1  
2 +-----+  
3 | 8802-3/802.3 REVISION REQUEST |  
4 +-----+  
5 DATE: July 15, 2015  
6 NAME: Glen Kramer  
7 COMPANY/AFFILIATION: Broadcom  
8 E-MAIL: gkramer@broadcom.com  
9  
10 REQUESTED REVISION:  
11 STANDARD: 802.3-2012  
12 CLAUSE NUMBER: 57  
13 CLAUSE TITLE: Operations, Administration, and Maintenance (OAM)  
14 PROPOSED REVISION TEXT:  
15  
16 1) Define a new variable pdu\_limit that has the value equal to  
17 aSlowProtocolFrameLimit attribute.  
18 2) In state diagram 57-6, replace the hardcoded value 10 with variable  
19 pdu\_limit in the following locations:  
20 - in state RESET  
21 - in two transitions out of state WAIT\_FOR\_TX  
22  
23 The detailed changes are shown in red in the attached file  
24 MR\_pdu\_limit.pdf  
25  
26  
27 RATIONALE FOR REVISION:  
28  
29 The maintenance request 1229 intended to make the maximum slow  
30 protocol frame rate configurable. To do so, it has added a new attribute

Figure 57–1—Transmit state diagram

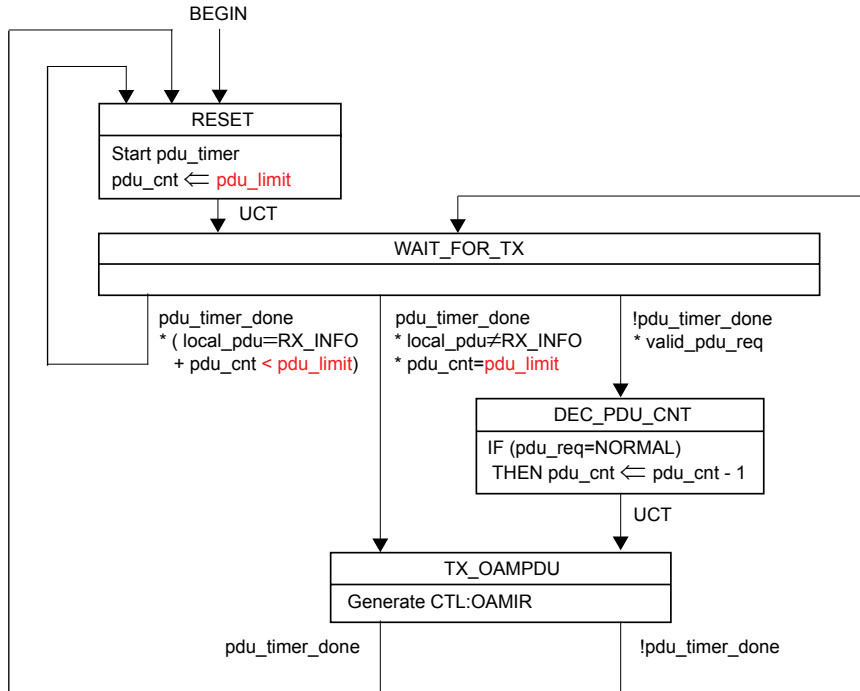
31 aSlowProtocolFrameLimit (see 30.3.1.1.38) and modified the  
32 requirements in 57A.2 (see  
33 [http://www.ieee802.org/3/maint/requests/maint\\_1229.pdf](http://www.ieee802.org/3/maint/requests/maint_1229.pdf)).  
34  
35 However, the necessary changes to state diagram 56-7 were missed  
36 at that time. This state diagram has the value "10" hardcoded  
37 in several places, effectively limiting the number of OAMPDUs that  
38 can be sent by an OAM client to 10.  
39  
40  
41 IMPACT ON EXISTING NETWORKS:  
42  
43 None. The changes are required to ensure that the actual maximum OAMPDU  
44 rate matches that provisioned by the user or the network operator.  
45  
46  
47  
48

##### pdu\_limit

This variable represents the maximum number of OAMPDUs that are allowed to be transmitted in one second. The value of pdu\_limit variable is equal to the value of the aSlowProtocolFrameLimit attribute (see 30.3.1.1.38).

OAM sublayer entities shall implement the Transmit state diagram shown in Figure 57–1.
